**Telecommunications and exchange
between information technology
systems — Requirements for local and
metropolitan area networks —**

**AMENDMENT 6: Maintenance #13:
Power over ethernet over 2 pairs**

IEEE Std 802.3cq™-2020

Amendment 6: Maintenance #13: Power over Ethernet over 2 pairs

Figure 33–16—PD state diagram

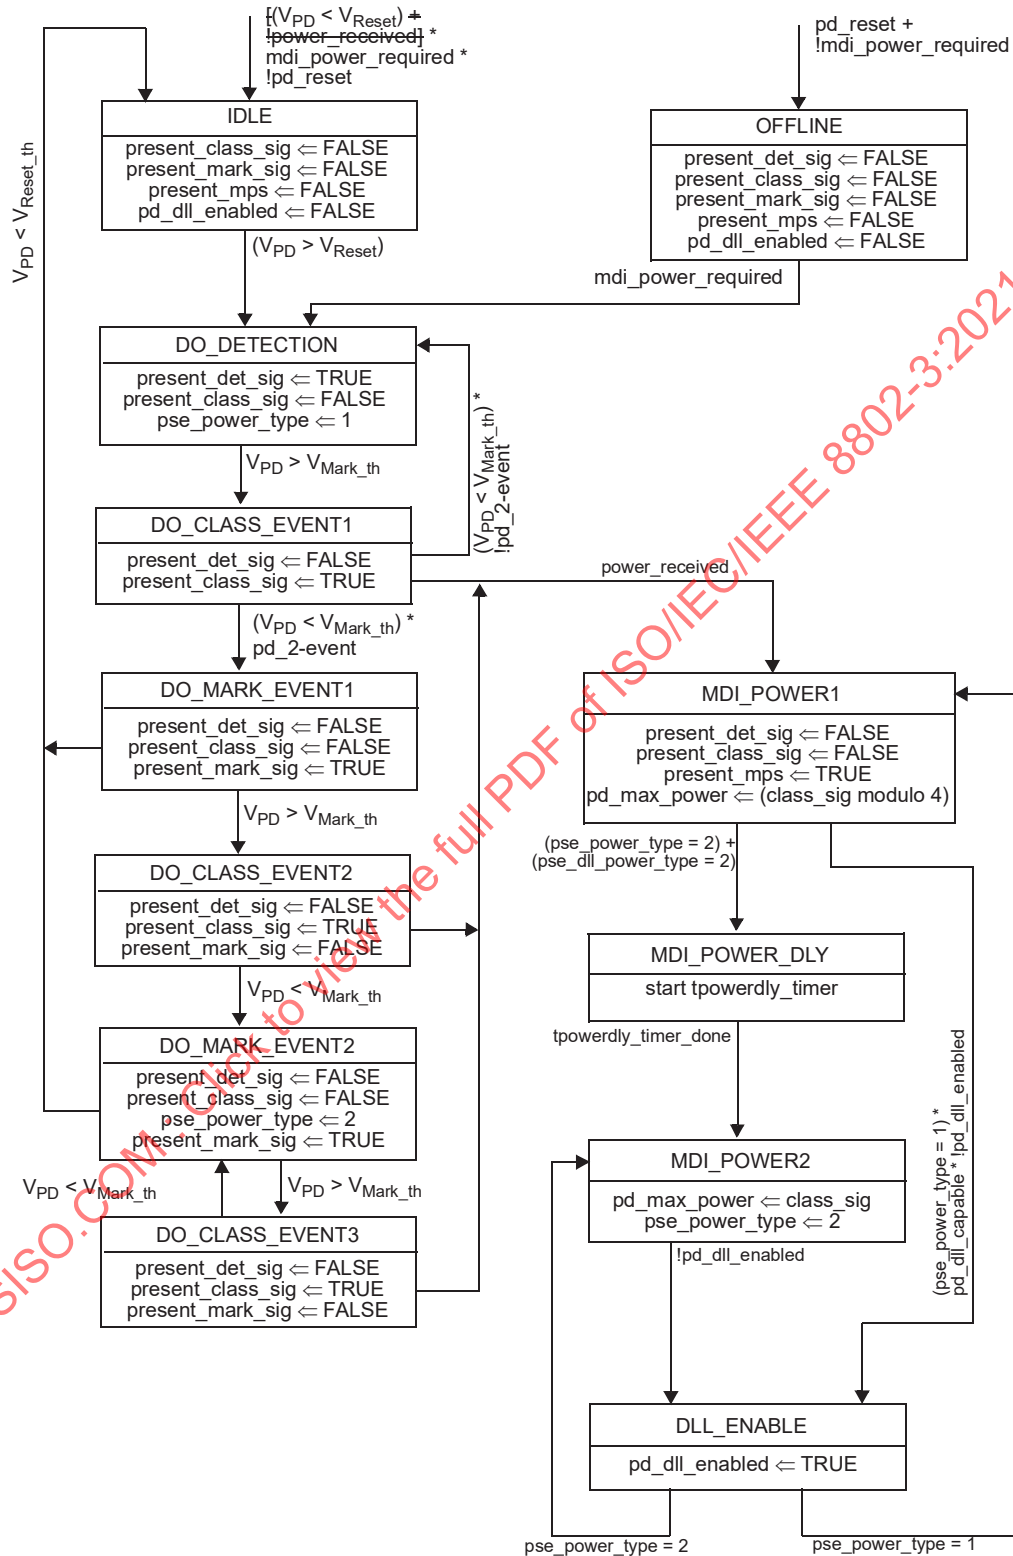
Change Figure 33–16 as follows:
